UNITED STATES PATENT AND TRADEMARK OFFICE

Office Action Summary	Application No. 10/574,694	Applicant(s) MATULA, JOUNI	
	Examiner Andrew Janca	Art Unit 1774

DETAILED ACTION

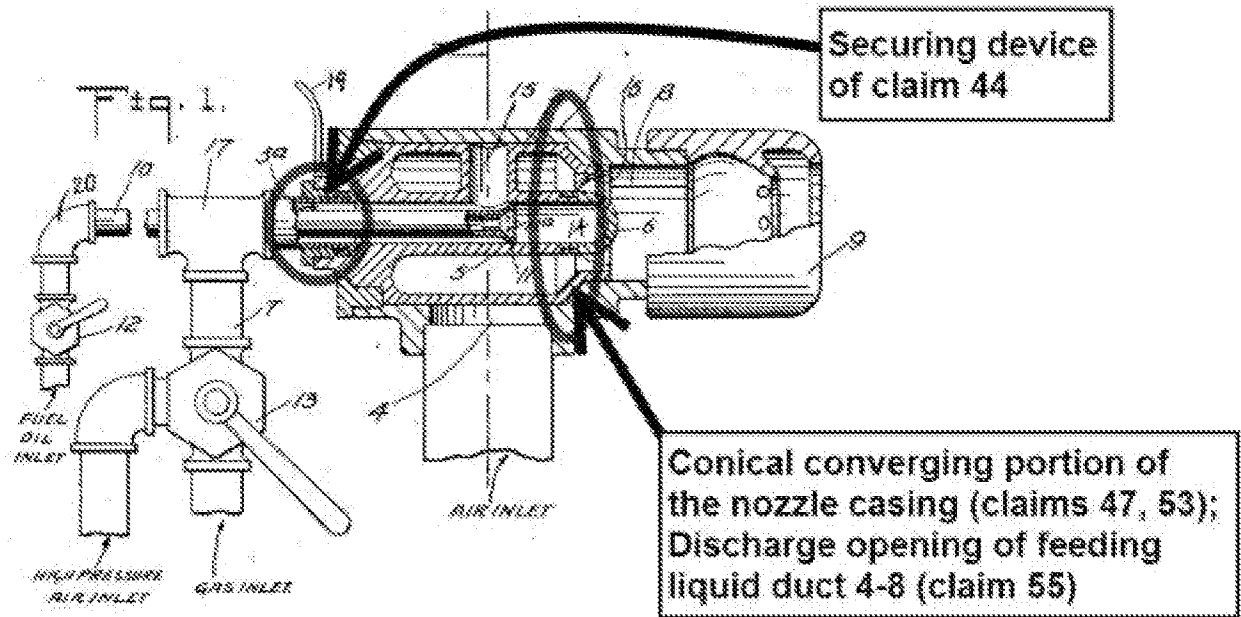
19. With regard to claim 44, Clements discloses the feeding device according to claim 35, further comprising a securing device, the unnumbered ring to which valve handle 19 is attached (see figure 1 as annotated below), that secures the mixing liquid feed duct 7-5a-5-6 to the nozzle casing 1 so that a [angular] position of the mixing liquid

22. With regard to claim 47, Clements discloses the feeding device according to claim 35, further comprising a conical converging portion in the nozzle casing 1 defining a converging cross-sectional area of a flow path of the feeding liquid to increase a flow velocity of the feeding liquid (figure 1, annotated above).

28. With regard to claim 53, Clements discloses the feeding device of claim 52 wherein the nozzle casing 1 includes a converging casing section which forms a converging section of the flow path for the feeding liquid (figure 1, annotated above).

30. With regard to claim 55, Clements discloses a feeding device which may be used for feeding a chemical into a process liquid flowing through a process liquid flow duct 8-9, the feeding device comprising: a feeding liquid duct 4-8 including a discharge opening (see figure 1 as annotated above) capable of discharging a feeding liquid to the process liquid; a mixing liquid feed duct 7-5-5a-6 extending through the feeding liquid duct and the mixing liquid feed duct is capable of passing a mixing liquid, wherein the mixing liquid feed duct includes an sidewall 5-6 and an end wall, the closed tip of 6 (figures 1, 3), wherein the end wall extends beyond the discharge opening of the feeding liquid duct 4-8 and extending into the process liquid flow duct 8-9; a mixing space 14 in the mixing liquid feed duct, wherein the mixing space is adjacent the end wall and within the sidewall 5-6 of the mixing liquid feed duct; a chemical feed duct 10 extending through the mixing liquid feed duct and having a discharge opening 11 proximate to the mixing space in the mixing liquid feed duct, wherein the chemical flows through the chemical feed duct and enters the mixing space to form a mixture of the chemical and the mixing liquid, and a mixture discharge opening, one or more apertures at the end of 6, in the side wall 5-6 of the mixing liquid feed duct, wherein the mixture discharge opening is configured to discharge the mixture of the chemical and the mixing liquid from the mixing space into the mixing liquid flowing into or from the discharge opening of the feeding liquid duct 4-8 (figures 1, 3; 1:36 left column forward). Regarding
